Informal Document No. 16

32nd GRSP, agenda item B.1.5.
Prepared by the expert from
Germany

PROPOSAL FOR DRAFT 03 SERIES OF AMENDMENTS TO REGULATION No. 29
(Cabs of commercial vehicles)

Figure 1a and 1b:

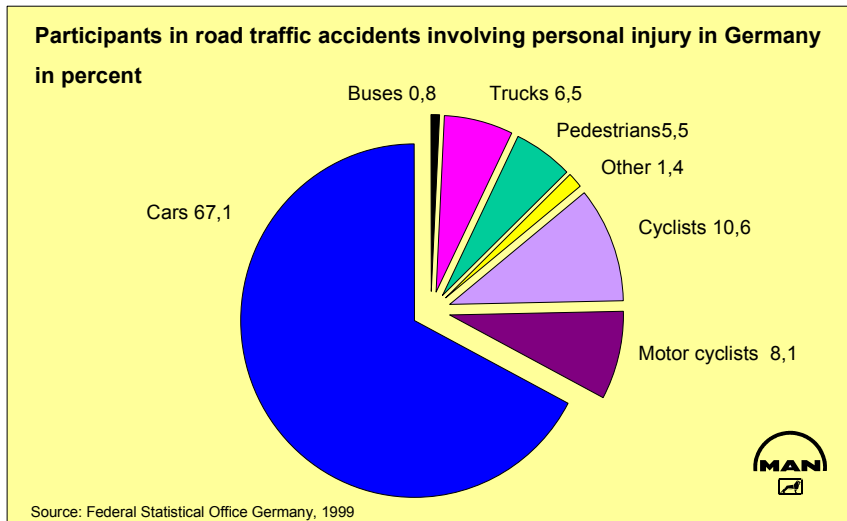
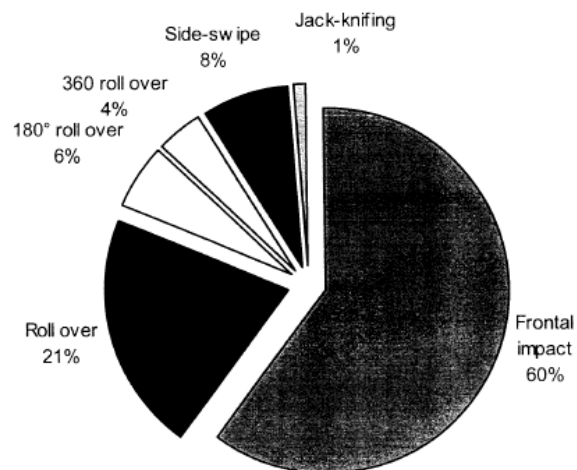
The proposed modifications have very limited potential to reduce the number of injured drivers and co-drivers of vehicles of category N with cabs / chassis. This can be demonstrated by the interpretation of the existing accident data, see figures 1a, 1b, 2 and 3.

In our view this proposal leads to new cab design only but not to a noticeable reduction of the number of accidents and the number of injured people.
